VIRGINIA ELECTRIC AND POWER COMPANY Richmond, Virginia 23261

VIRGINIA ELECTRIC AND POWER COMPANY SURRY POWER STATION (SPS) UNITS 1 AND 2 SUBSEQUENT LICENSE RENEWAL APPLICATION RESPONSE TO REQUESTS FOR ADDITIONAL INFORMATION SET 1 – REGARDING ENVIRONMENTAL REVIEW

RESPONSE TO RAIS SET 1 REGARDING SPS SLRA ENVIRONMENTAL REVIEW

Virginia Electric and Power Company (Dominion Energy Virginia or Dominion) Surry Power Station Units 1 and 2

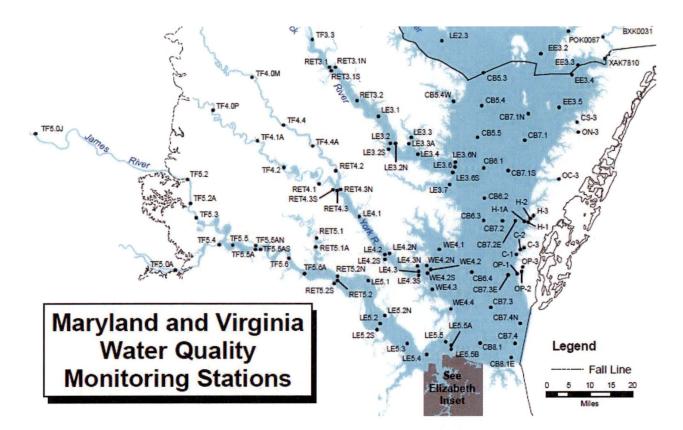
- a. Provide a basis for concluding the 1975 high ambient water temperatures recorded are representative of the discharge canal in late summer under current SPS operating conditions.

a. In 1975, a study was performed during August to determine temperatures within the SPS thermal mixing zone. The survey was conducted during slack before ebb and slack before flood tidal conditions during a period when the station had been operating at near full capacity for several days. Background temperatures of 29.6°C and 28.7°C (85.6°F and 83.7°F) were measured in the James River during the study at a location close to Chesapeake Bay Monitoring Program station RET5.2. Both temperatures are very close to maximum historical James River temperatures measured at station RET5.2 indicating that the survey reflects close to maximum expected mixing zone temperatures.

Below is a figure showing James River temperatures measured during August of each year 1985–2017 at a Chesapeake Bay Program monitoring station RET5.2 that is located upriver from SPS (see map below). The station is located outside of the influence of Surry's thermal mixing zone.

FIGURE 1

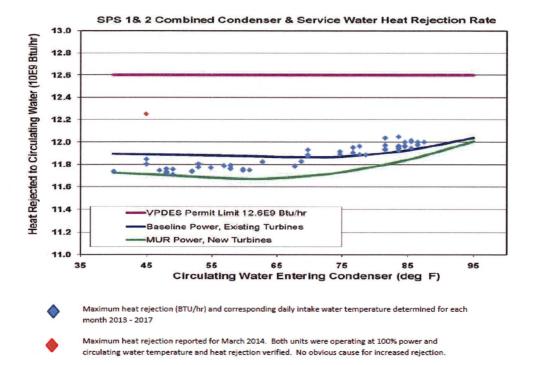
e. Has there been a change (increase or decrease) in the temperature rise of water across the condensers under current operating conditions of SPS and as a result of SPS power uprates? If so, please discuss. If there has been no change in maximum temperature rise of water across the condenser under current SPS operating conditions, provide a basis for concluding this.

- e. Prior to implementation of the Measurement Uncertainty Recapture (MUR) Power and Alstom Turbine (TRP) uprates in 2010 and 2011, the impacts to waste heat rejection (BTU/hr) and resulting discharge temperature were evaluated using the Performance Evaluation of Power Station Evaluation (PEPSE) heat balance model for SPS 1 & 2. The PEPSE model was modified to reflect the MUR and TRP uprates using a maximum cooling water intake temperature of 95 degrees.

The analysis projected that implementation of the MUR uprate alone would result in an increase in the full plant thermal discharge to the James River from a baseline of 12.04 x 10^9 BTU/Hour to approximately 12.26 x 10^9 BTU/Hour. However, under TRP uprate conditions, the efficiency of the steam turbine, generator and condenser system to convert thermal energy originating from the reactor into electric power at the switchyard would be improved over that of the existing Siemens steam turbines. Consequently, evaluation of the combined MUR and TRP uprates projected that the TRP uprate would decrease the MUR heat rejection load from 12.26 x 10^9 BTU/Hour to 12.11 x 10^9 BTU/Hour.

Figure 1 compares the heat rejection rates projected to result from the MUR and TRP uprates (MUR Power, New Turbines) with the heat rejection rates existing prior to implementation of the uprates (Baseline Power, Existing Turbines). Figure 1 was discussed with VADEQ during a presentation given on January 10, 2010 prior to the uprates. At that time the analyses had indicated that implementation of the MUR and TRP uprates would result in a reduction in heat rejection from baseline for condenser inlet temperatures throughout the range from 40°F to 95°F. Because cooling water volumes were not impacted by the uprates, a decrease in water temperatures would also be predicted throughout this range.

Superimposed on Figure 1 (diamonds) are actual maximum heat rejections (BTU/hr) and corresponding daily intake temperatures determined for each month from 2013 – 2017. These data suggest the following:
